Office Action Summary

10/747,601

KEUM, DONG YEAL

DETAILED ACTION

FIG. 3B

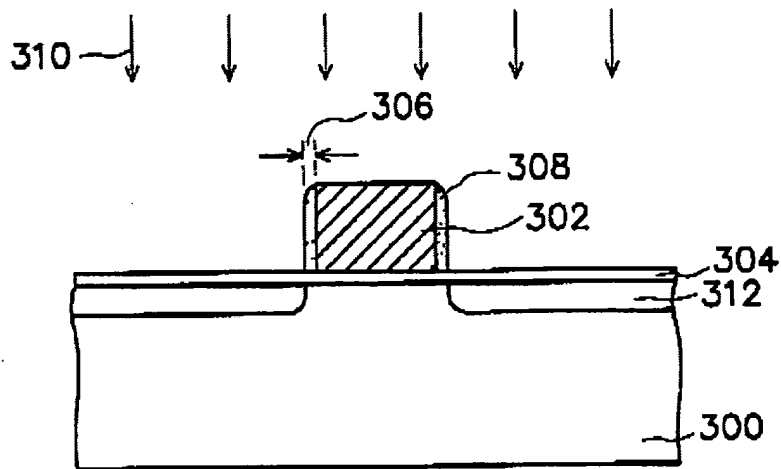
Claim 1 is rejected under 35 U.S.C. 103(a) as being unpatentable over Huang-Lu et al, US Patent Application Publication 2001/0044191 and Pfiester, US Patent 5,264,380. See figures below.

Regarding claim 1, Huang-Lu teaches a method for fabricating a transistor comprising:

forming a gate electrode **302** on a semiconductor substrate **300**,

forming a first preliminary source/drain region and a pocket junction region **312** through a first ion implantation process **310** using the gate electrode as a mask, the pocket junction region being formed under the first preliminary source/drain region,

FIG. 3D

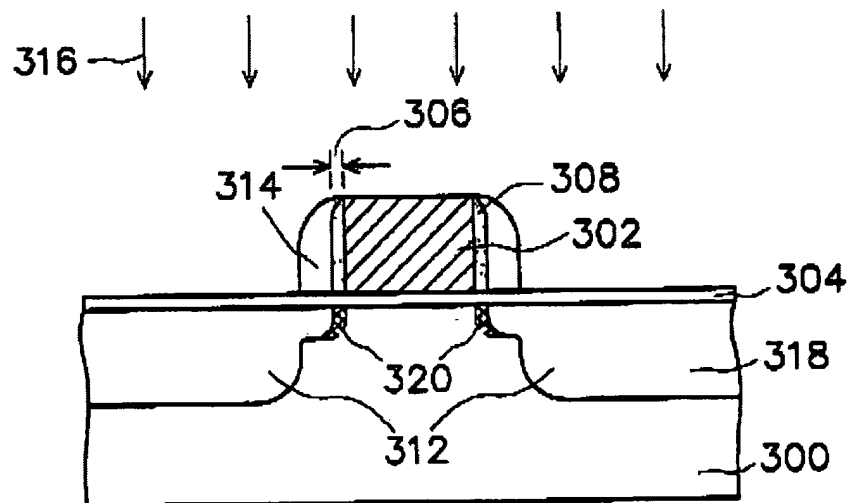
forming spacers **314** on sidewalls of the gate electrode,

forming a second preliminary source/drain region through a second ion implantation **316** process using the spacers as a mask (Figure 3D),

removing the nitride layer and the first oxide layer on the surface of the substrate (Fig 3D),

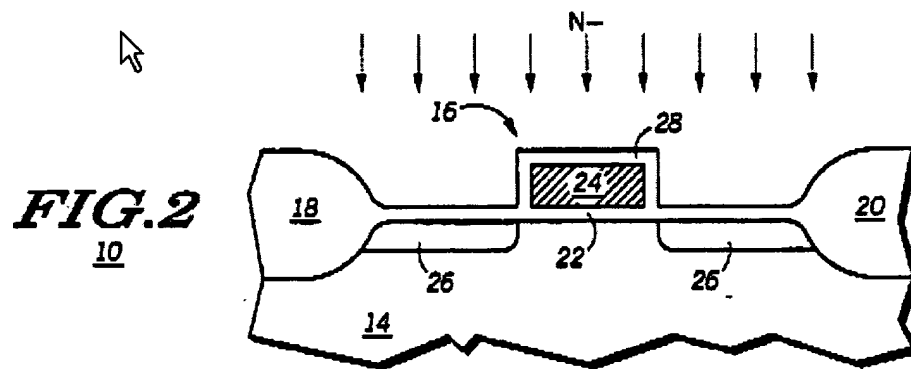
Huang-Lu fails to teach forming a first oxide layer with uniform thickness on the substrate including the gate electrode. Pfiester teaches forming a first oxide layer **28** with uniform thickness on the substrate including the gate electrode. It would have been
